Request Summary

- Requesting approval of three variances for two new monument signs
 - 1 sign permitted per 500 SF of frontage (only 1 allowed for this site)
 - Signs are less than 15 ft from the ROW and do not have required landscaping
 - 50 SF landscaping required around base of sign
 - One sign for main entrance (west) and one for shipping entrance (east)
 - Signs are the same size (30 SF) and height (9 ft 6 in) and have directional arrows
 - 10 ft maximum sign height in OCT
 - West sign is 9.7 ft from ROW, east sign is 2.5 ft from the ROW
 - Minimum 15 ft setback from ROW required

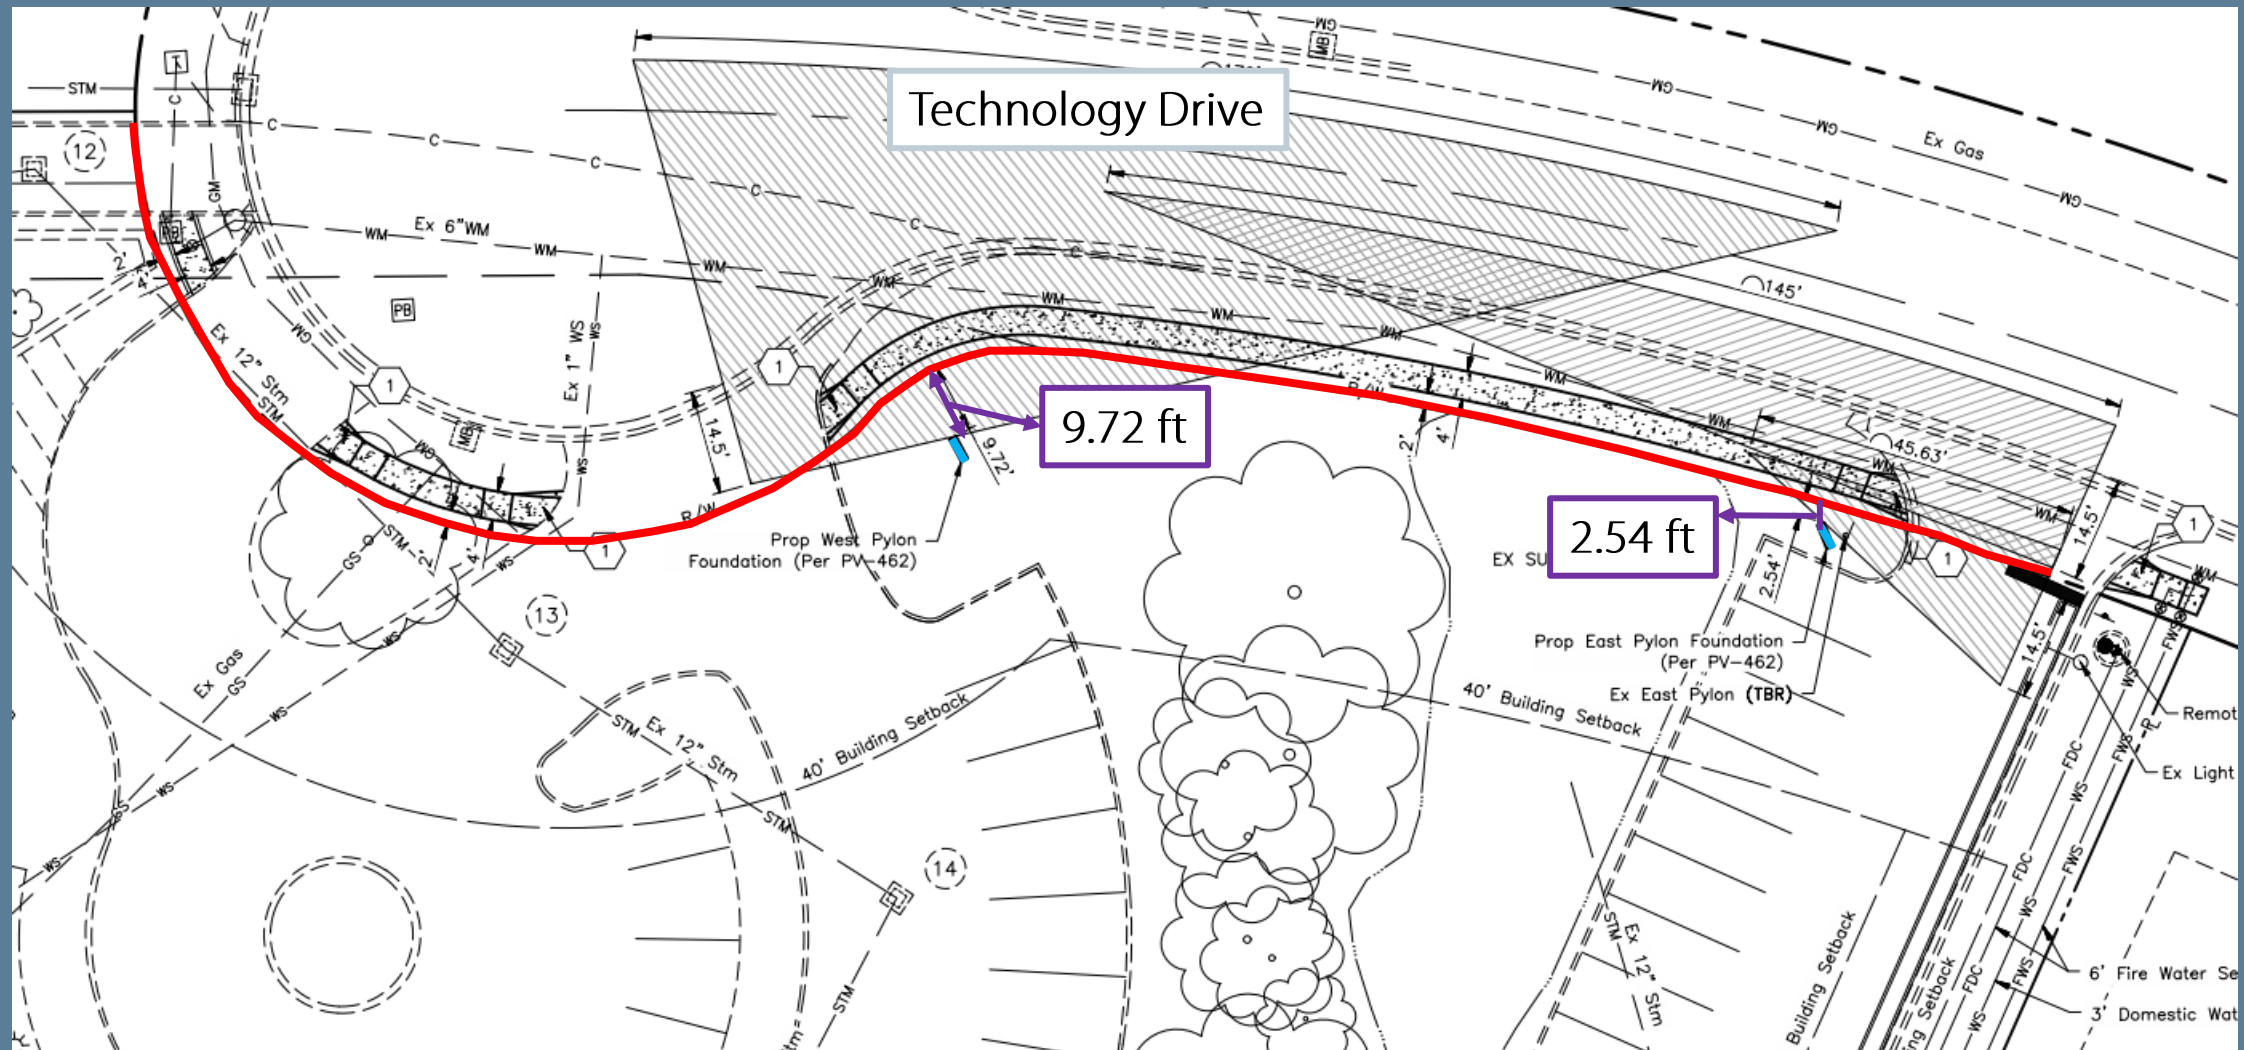
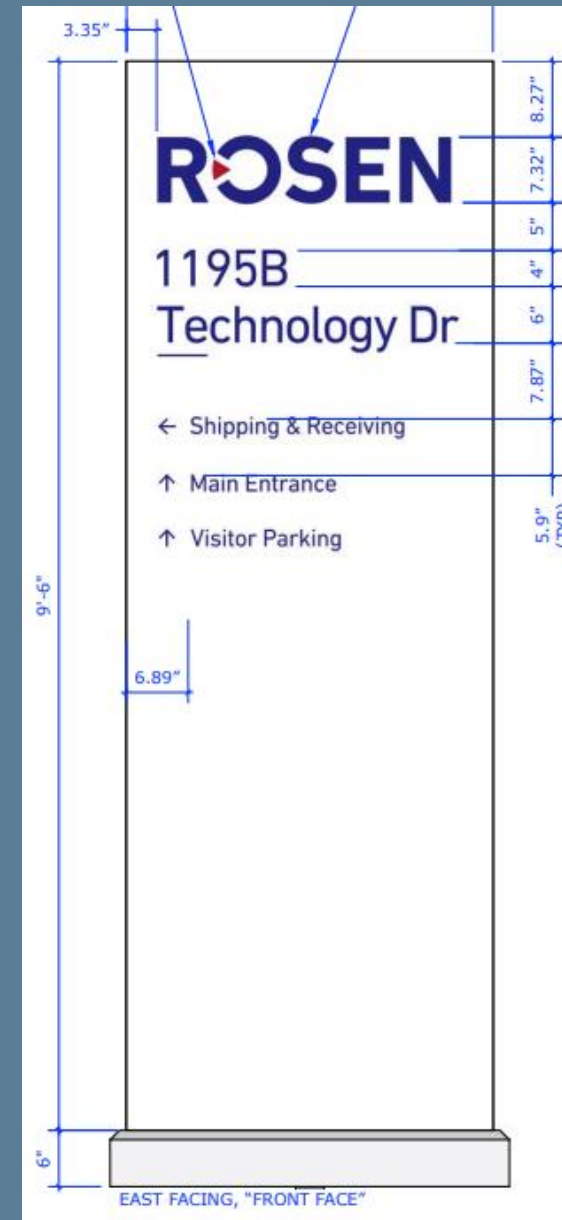
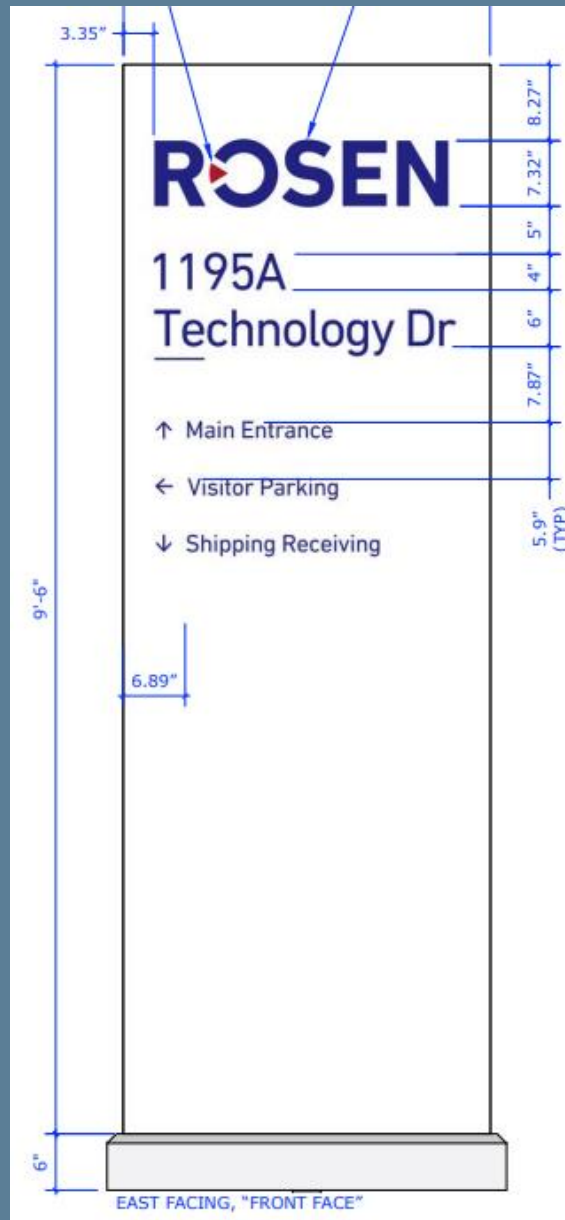
- Requested Variances
 - Ch 1165.08(b)(8) – Permanent Signs
 - Code allows one monument sign per 500 ft of street frontage
 - 1 monument sign allowed for this site; 2 are proposed
 - Ch 1165.08(b)(1) – Permanent Signs
 - Monument signs must be 15 ft from the ROW
 - The proposed signs are 2.5 ft and 9.7 ft from the ROW
 - Ch 1165.09(a)(3)(C) – Design, Construction, and Maintenance of Signs
 - Monument signs must have 50 SF of landscaping around the base
 - No landscaping is provided

- Staff has no objection to all three variances
 - Both signs are closer to the ROW than permitted but do not obstruct the sight triangle
 - Confirmed by Engineering
 - Site is at end of cul-de-sac, so signs are not visible from a major roadway
 - East sign (shipping drive) is replacing existing sign, but is ~2x the size
 - The applicant states there is limited area for landscaping around the base and moving the signs could affect mature trees on the site
